May 24, 2021

**RE: Burger King - Alameda
5970 Alameda Ave. NE
Grading and Drainage Plan
Engineer's Stamp Date: 05/10/21
Hydrology File: C18D022A**

DAVID SOULE P.E. #14522	BURGER KING ALAMEDA 5970 ALAMEDA BLVD NE	DRAWN BY: WCVJ DATE: 5-04-21
	GRADING AND DRAINAGE PLAN	210210048-LAYOUT-5-05-21
5/10/21 DAVID SOULE P.E. #14522	 Rio Grande Engineering 1606 CENTRAL AVENUE SE SUITE 201 ALBUQUERQUE, NM 87106 (505) 972-0998	SHEET # --- JOB # 21021048

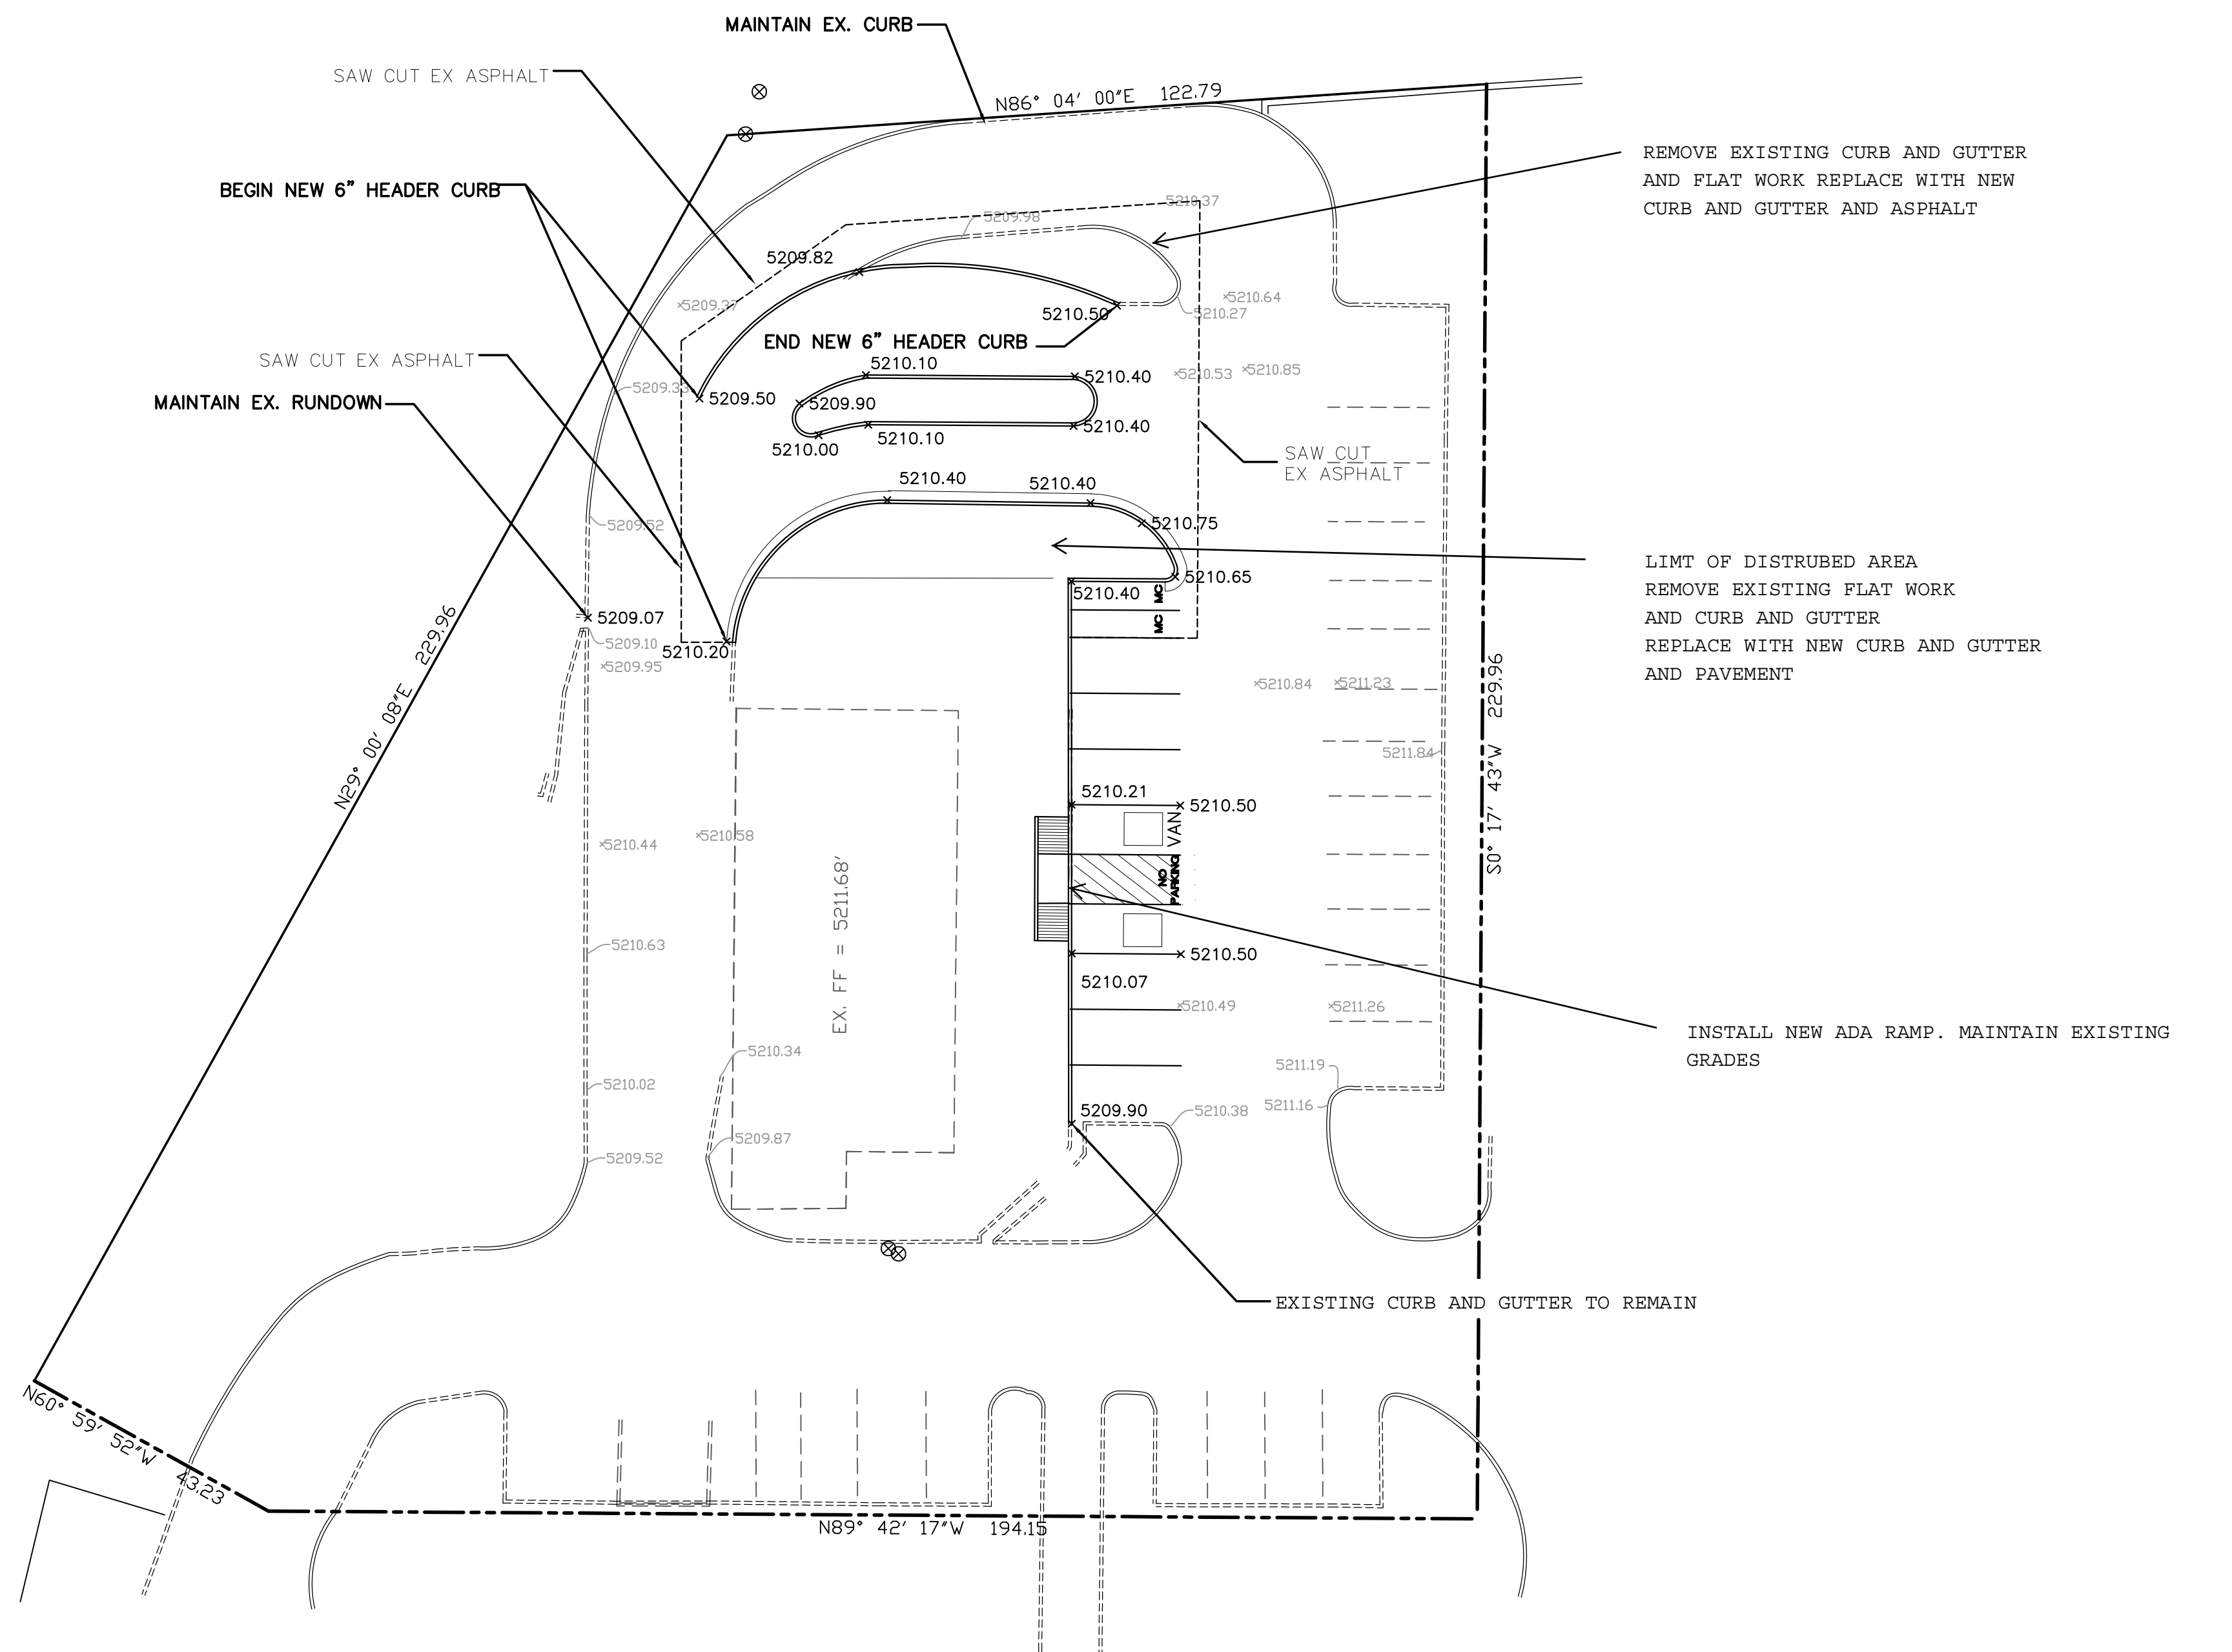
PO Box 1293
Based upon the information provided in your submittal received 05/10/2021, the Grading and Drainage Plans are approved for Building Permit.

Also, the Payment-in-Lieu of \$ **248.00** must be paid prior to Hydrology's Permanent Release of Occupancy approval. Please follow the instructions:
